MECHANISM, ELECTRICAL FIRING, T6 (FOR LAUNCHER, ROCKET, M-1).

Subject: Mechanism, Electrical Firing, T6 (For Launcher, Rocket, M-1).

REPORT of TEST

TEST SECTION
THE INFANTRY BOARD
FORT BENNING, GEORGIA

Modification of Circuit Testing Light on the Antitank Rocket Launcher M-1

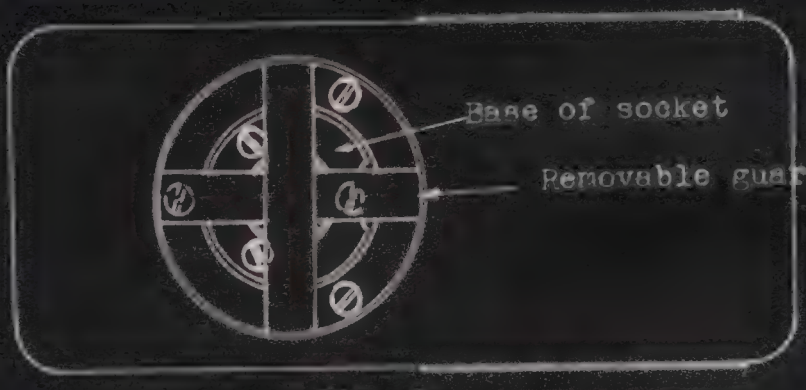
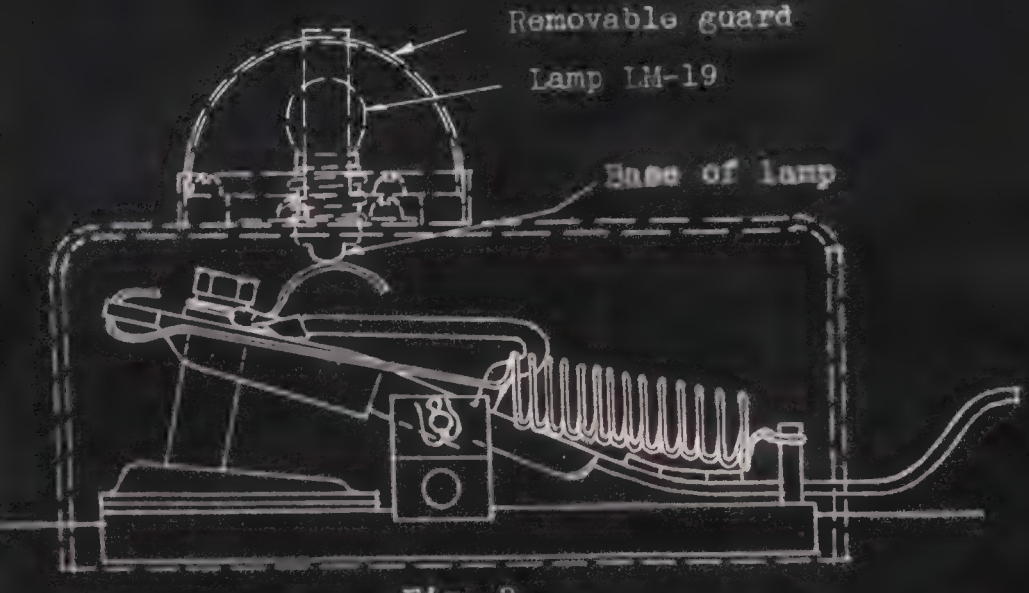
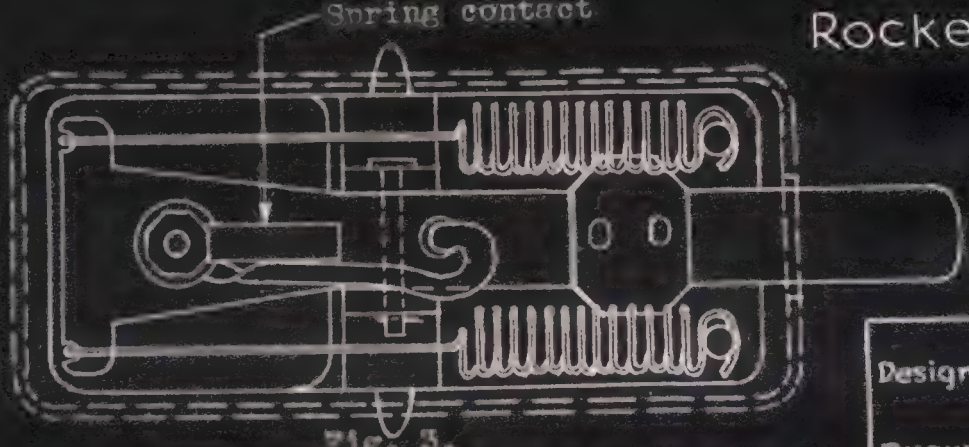
(a) Modification of the contact box cover by attaching a socket, bulb and guard as shown by Fig. 1 and Fig. 2, Appendix "E".

(b) Attaching a flat piece of metal to the contact plunger as shown in Fig. 3, Appendix "E".

(c) Removing the bulb mounted in the shoulder stock.

(3) The above modifications are simple and easy to incorporate into the launcher. This modification will provide:

(a) A method for testing the launcher wiring from the power source to the contact plunger.

(b) The bulb is removed from the circuit automatically when the lever is moved from the "Safe" to the "Fire" position.

(c) Both the firer and the loader can see the bulb and in case of a shorted trigger switch or the firer holding the trigger back, the loader can readily detect the presence of electric current on the contact plunger.

APPENDIX "F"

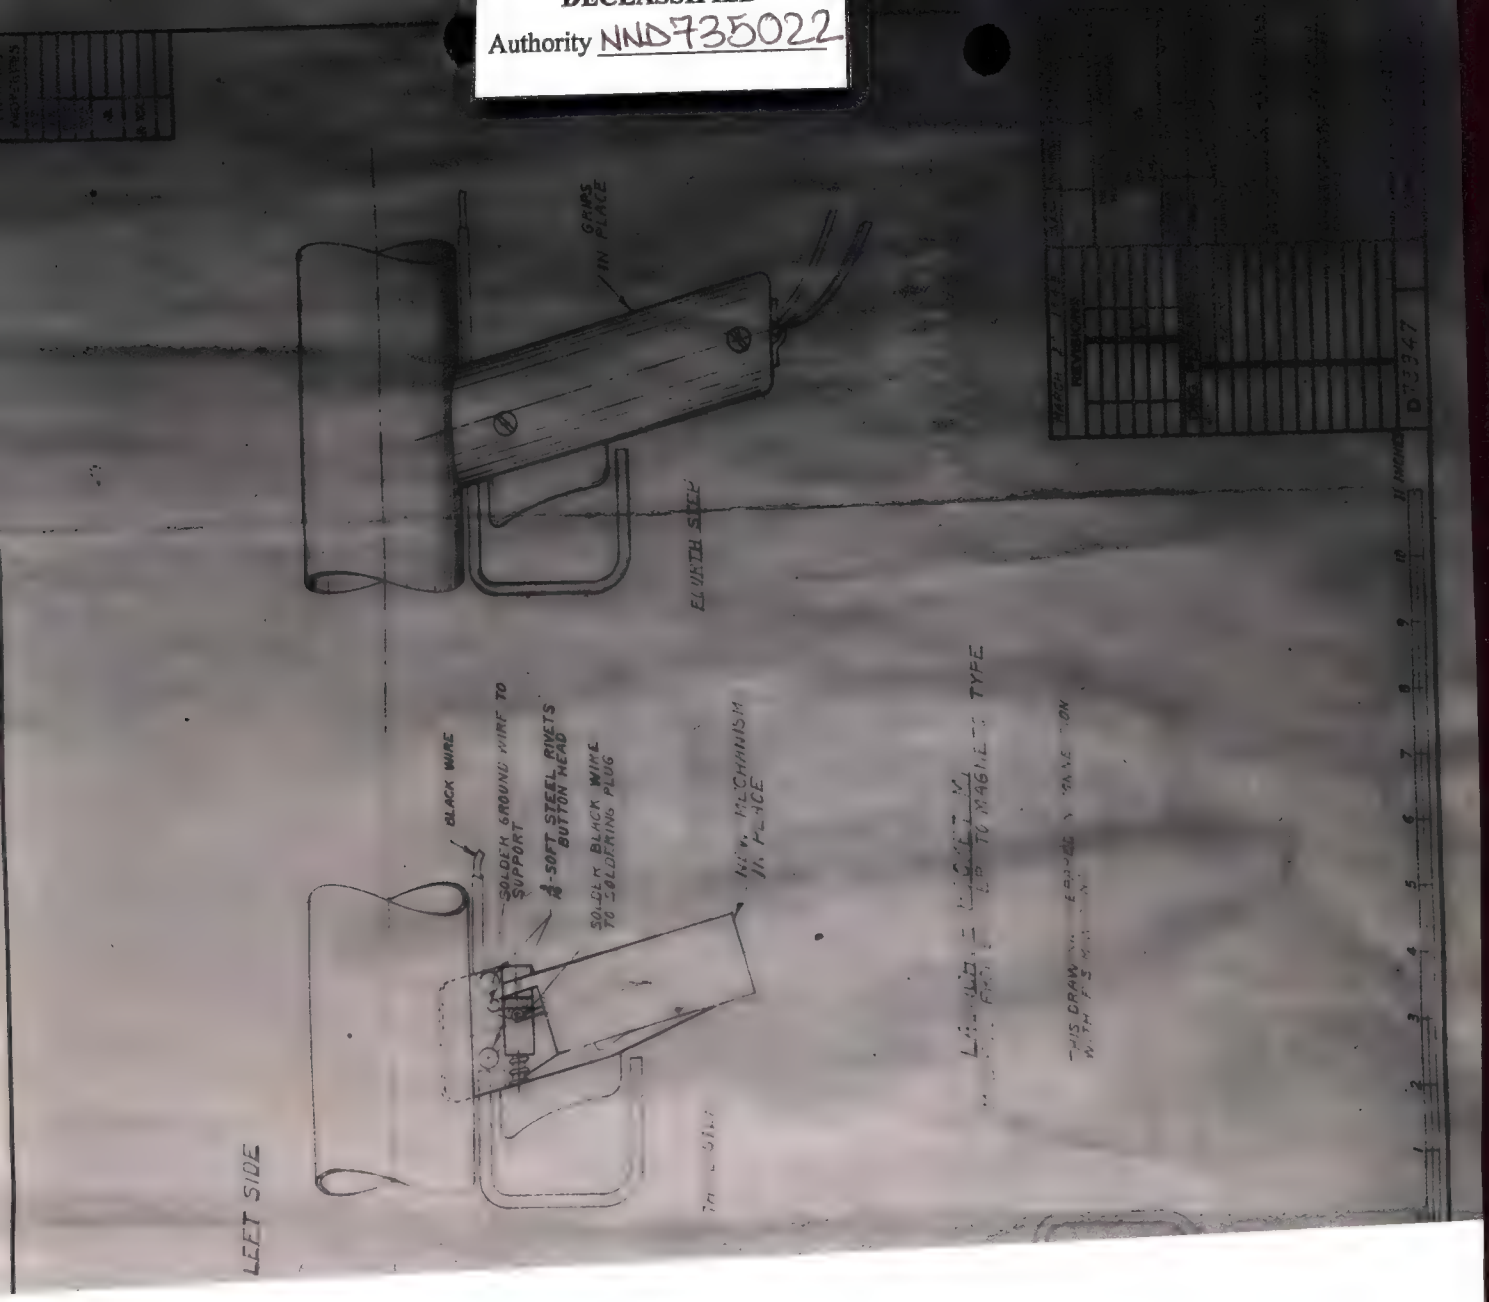
3. The Infantry Board recommends the immediate adoption of the subject mechanism, modified as indicated in paragraph 15 and 16, Report of Test, and illustrated in Appendices E and F.

PLATE 1

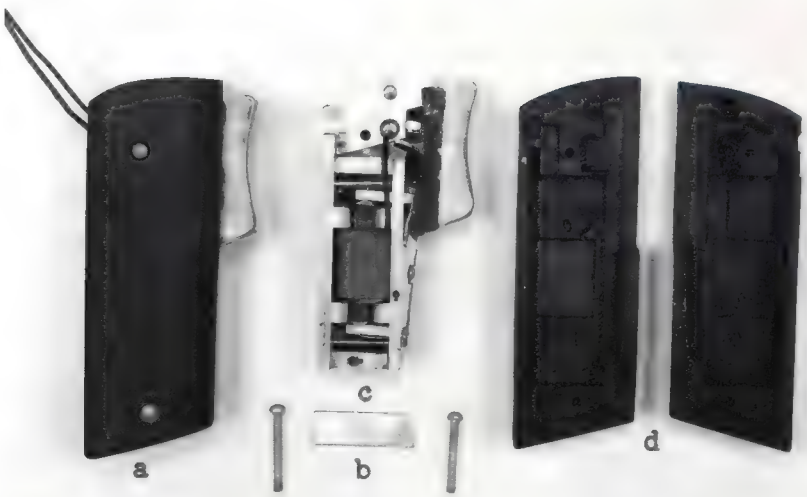
Examination of the defective firing mechanisms received indicated poor inspection. It is believed that these defects, mentioned in paragraph 8, can be eliminated without difficulty by proper inspection.

It was found that sand and mud could enter into the operating mechanism and prevent proper operation. (See Results of Test No. 7.) The sand entered the mechanism around the trigger and at points near the barrel where the grip stocks do not provide a tight fit. It is suggested that the trigger be housed in a soft flexible rubber housing (similar to that on the switch of the radio set SCR-536) and that the upper portions of the grip stocks, next to the barrel of the launcher have a closer fit.

The grip stocks give off a very offensive odor. Though not affecting the mechanical operation or ruggedness of the firing mechanism the odor from these stocks may cause personnel using the weapon to harbor a dislike for it. The plastic material in the grip stocks also warped when exposed to a temperature range of 140 to 190 degrees F for 24 hours.

View showing modification of testing method on launcher M1.

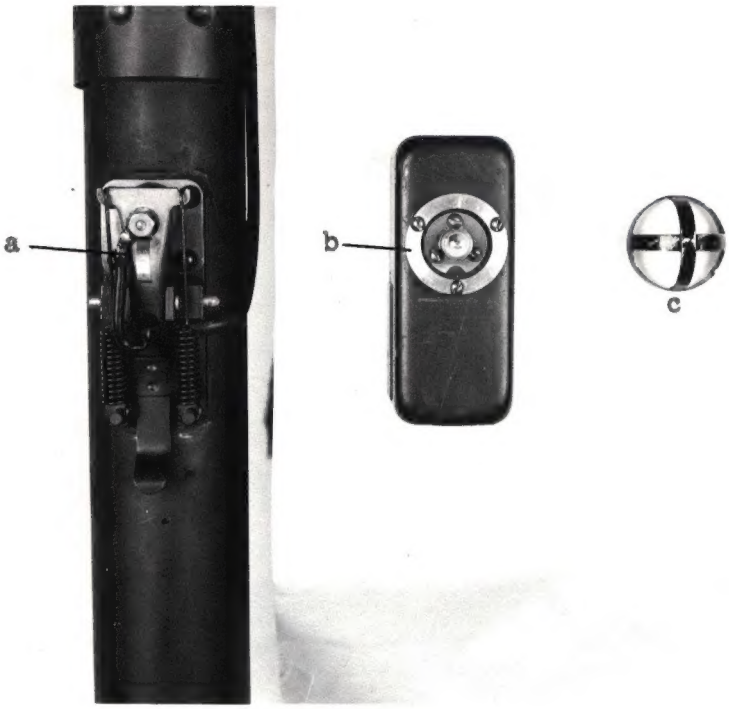
(4) The suggested method of testing the electrical system of the launcher was incorporated into a launcher used by the Test Section and has functioned satisfactorily. The modifications were made by using parts from a salvaged flashlight (TL-122) and do not materially increase the weight of the launcher. See Plates Numbers 4, 5 and 6 for views showing this method incorporated into the Launcher M-1.
